RESPONSE TO COMMENTS RESOURCE CONSERVATION AND RECOVERY FACILITY
INVESTIGATION WORK PLAN CNC CHARLESTON SC
7/20/1992
ENSAFE

**COMPREHENSIVE LONG-TERM
ENVIRONMENTAL ACTION
CHARLESTON NAVAL SHIPYARD
CHARLESTON, SOUTH CAROLINA**

**RESPONSE TO COMMENTS
RFI WORKPLAN
CHARLESTON NAVAL SHIPYARD**

JULY 20, 1992

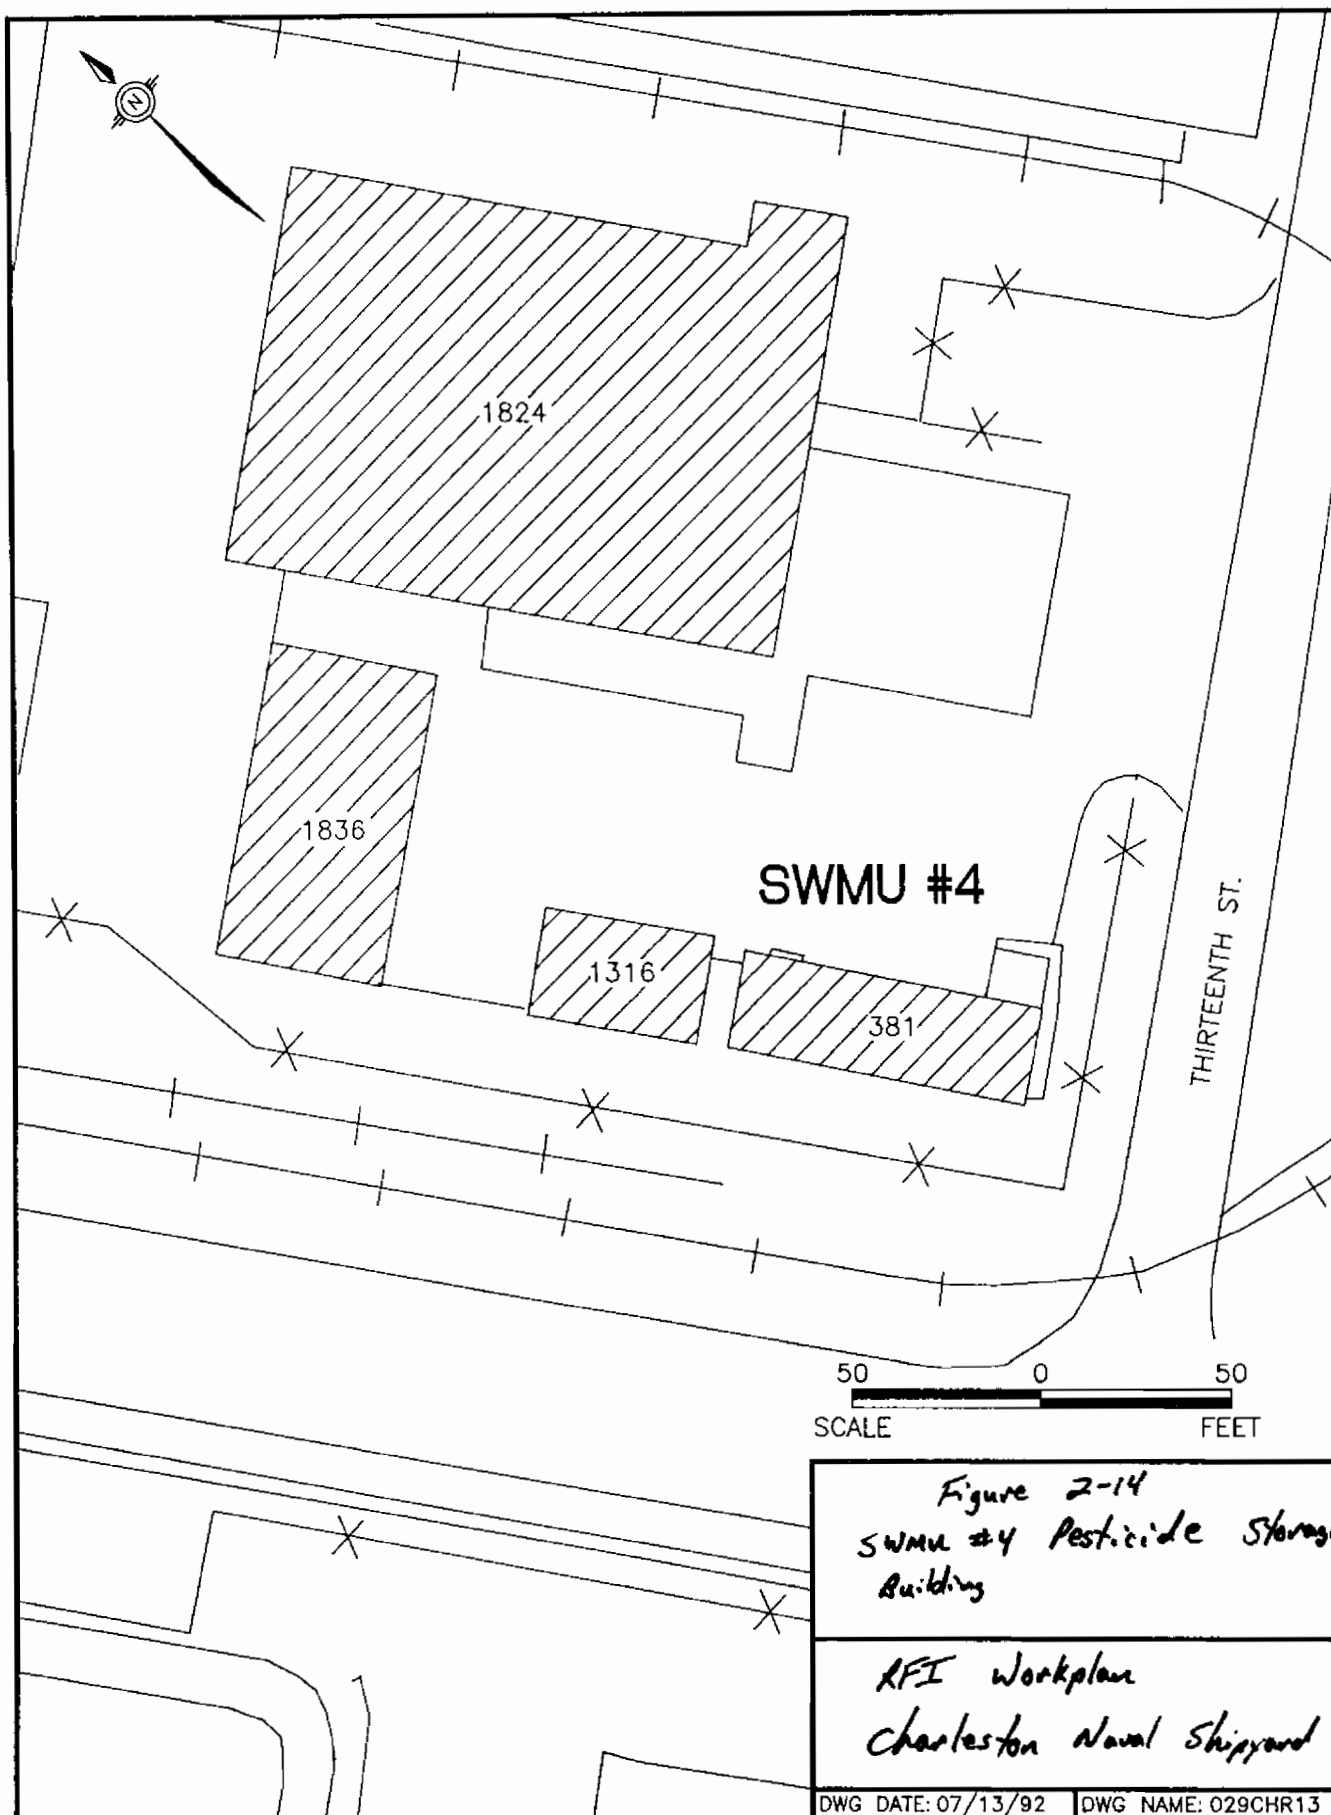
Do not include
